**MAINE TURNPIKE AUTHORITY**

**ADDENDUM NO. 2**

**CONTRACT 2026.08**

**KENNEBUNK MAINTENANCE FIRE**

SHEET NUMBER: C-103

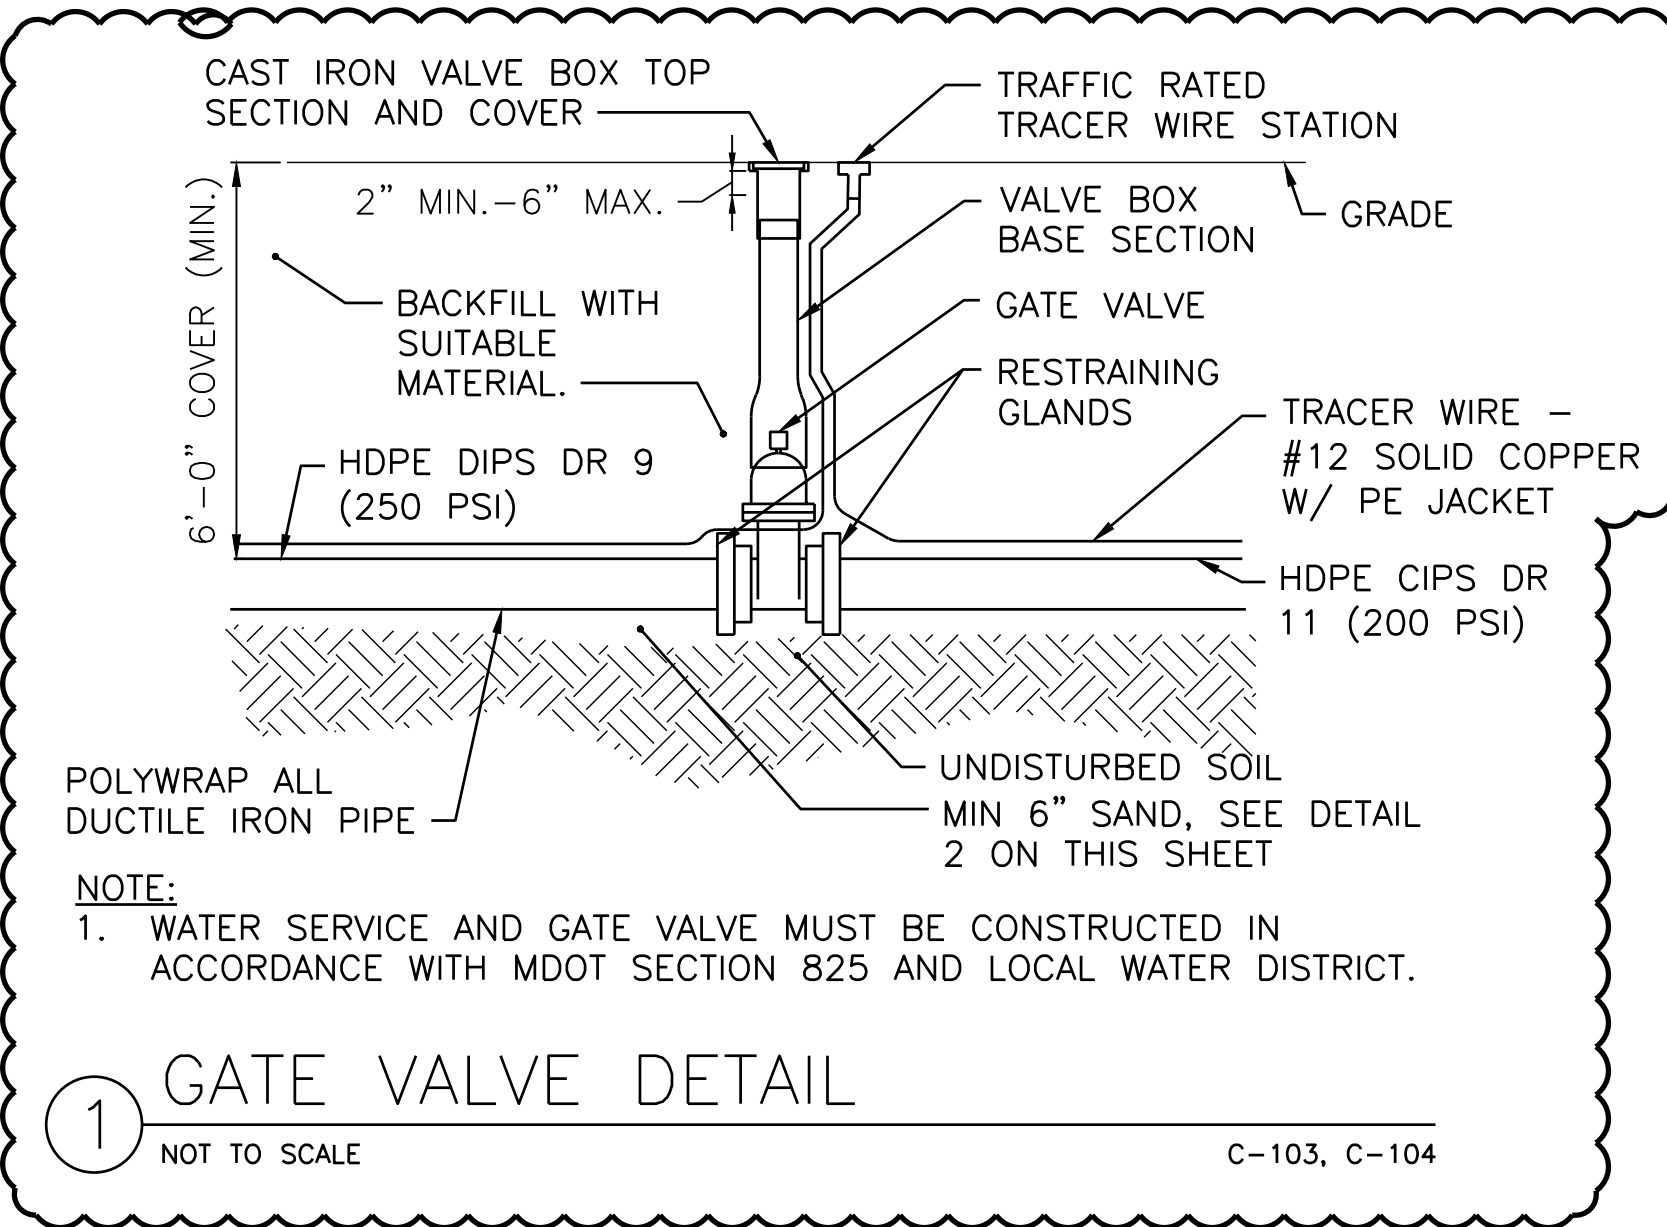
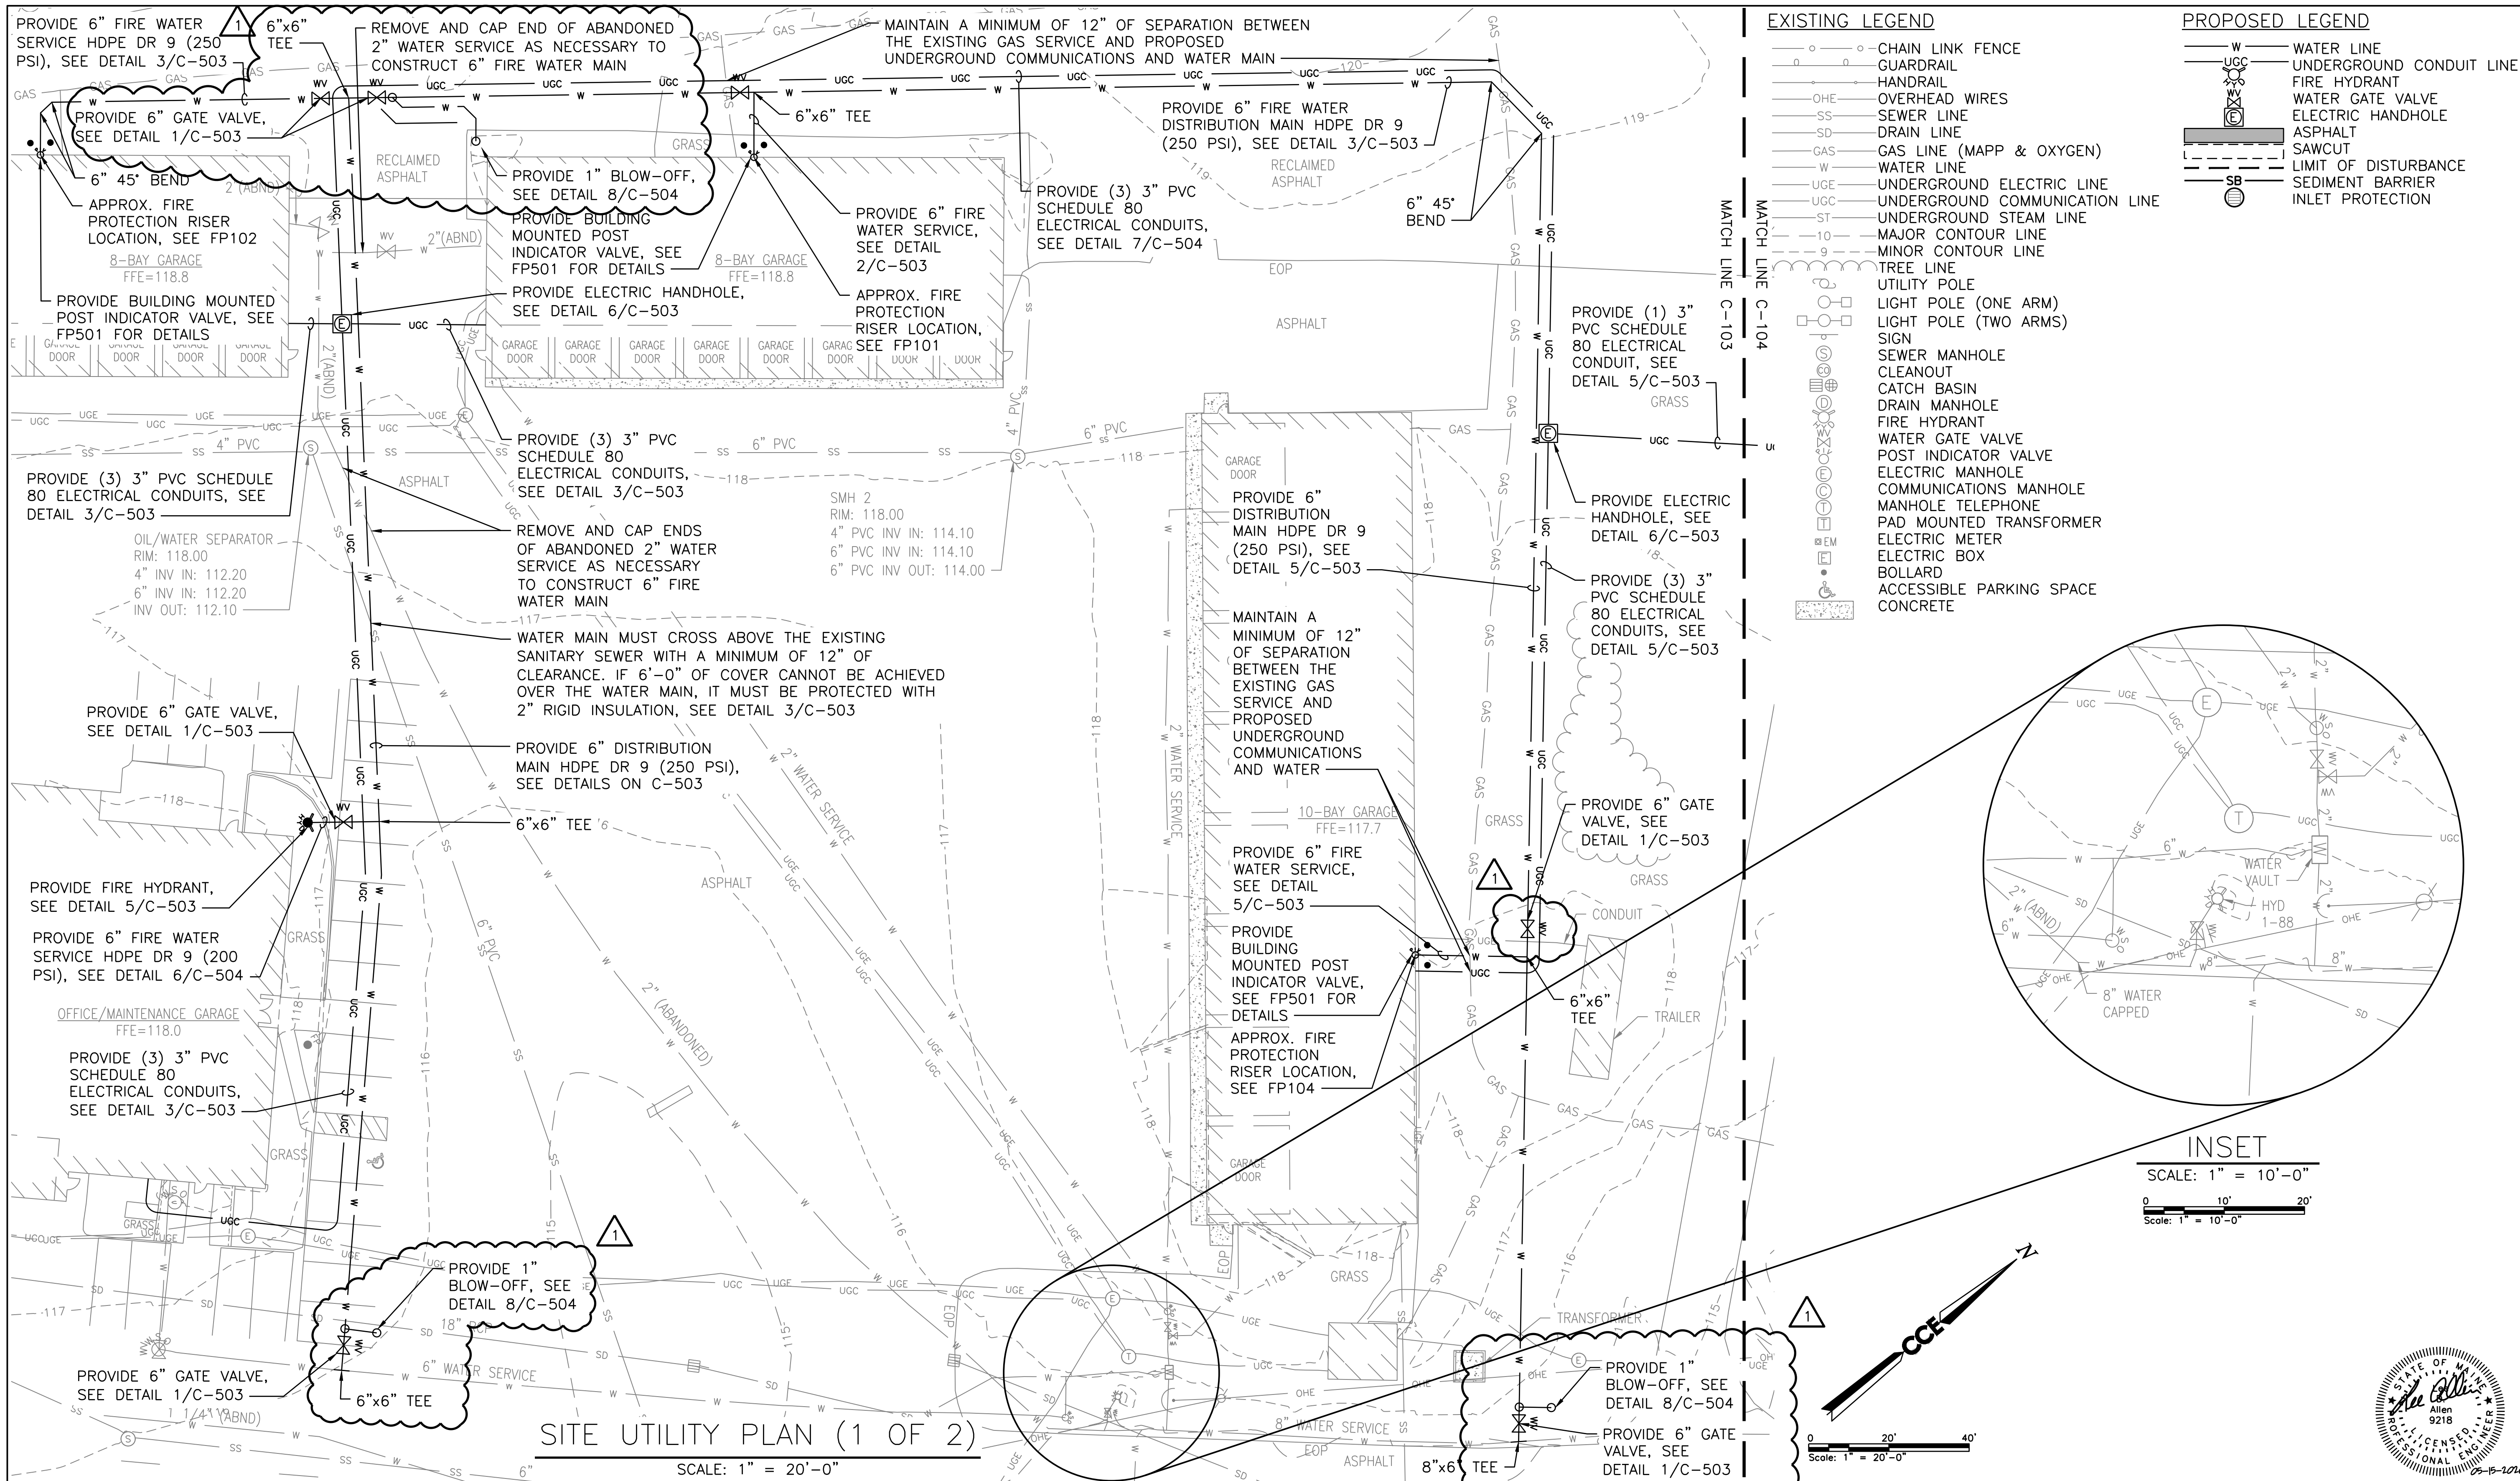
**Response:** Plan Sheets 8 and 10 provide locations for conduits entering the building. Detail for door access control system is shown on Plan Sheet 60.

1. A combination of HDPE and Ductile Iron Piping has been identified on the plans. Note that AWWA C900 PVC is an acceptable alternative to HDPE.
2. All plastic pipe will require tracer wire. See Details 1 and 3 on C-503.
3. All ductile iron pipe must be poly wrapped.
4. Three 1” blow-off valves have been added to the plans. See C-103 and Detail 8 on C-504.
5. Four 6” gate valves have been added to the plans. See C-103.

**4 THRUST BLOCK DETAIL**  
NOT TO SCALE

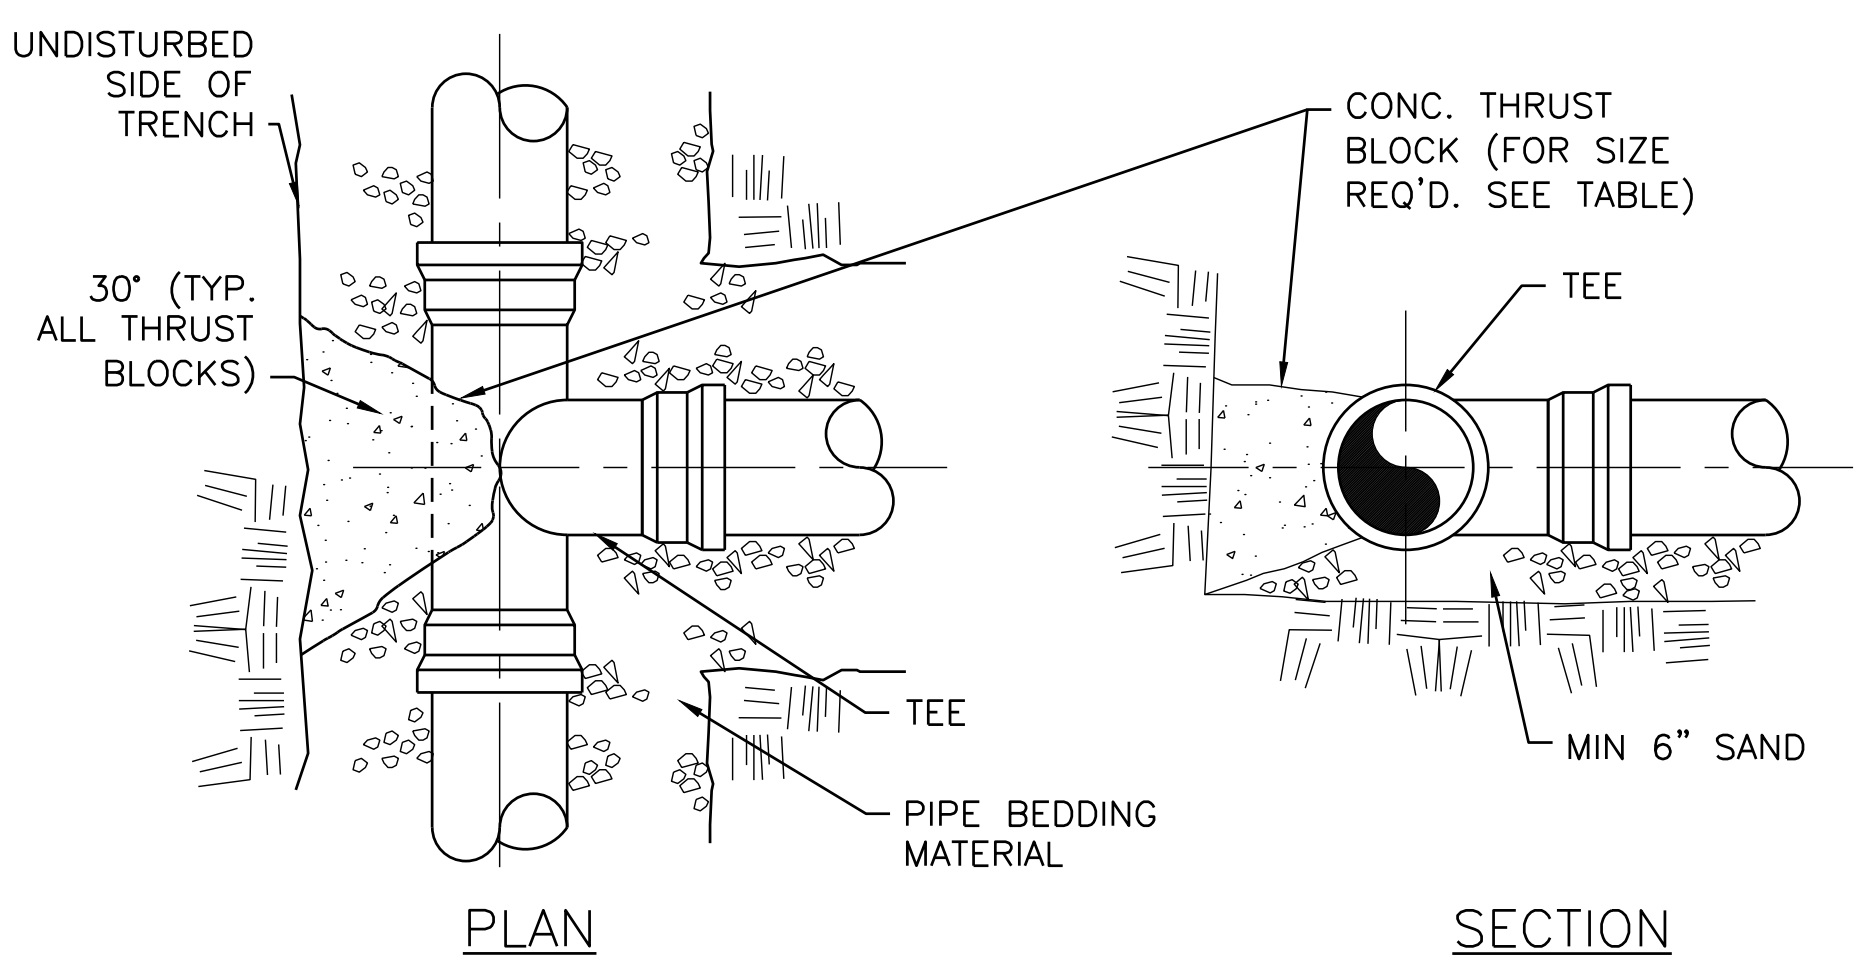
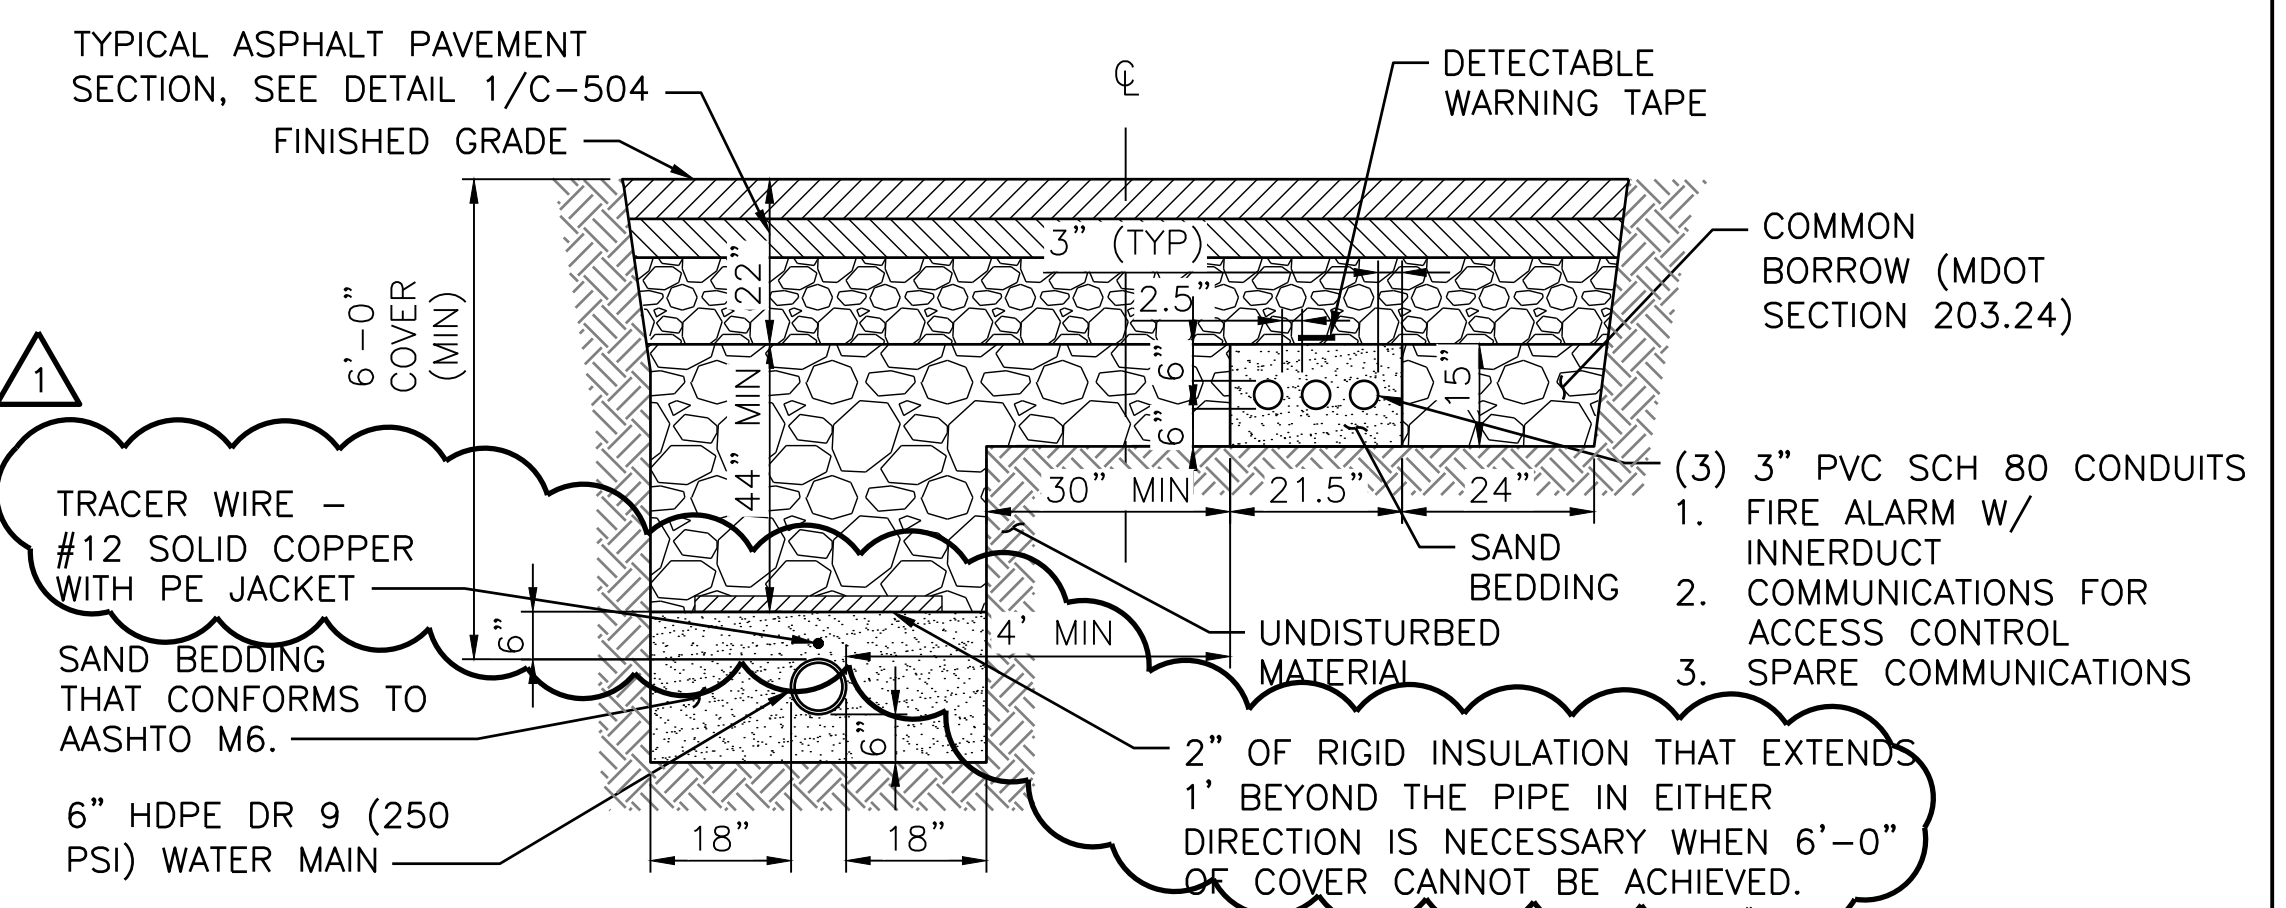
**Response:** No.
16. **Question:** Are precast thrust blocks acceptable in lieu of cast-in-place thrust blocks?  
**Response:** Yes, precast thrust blocks will be allowed provided there is no contact with the flanges/grip rings.
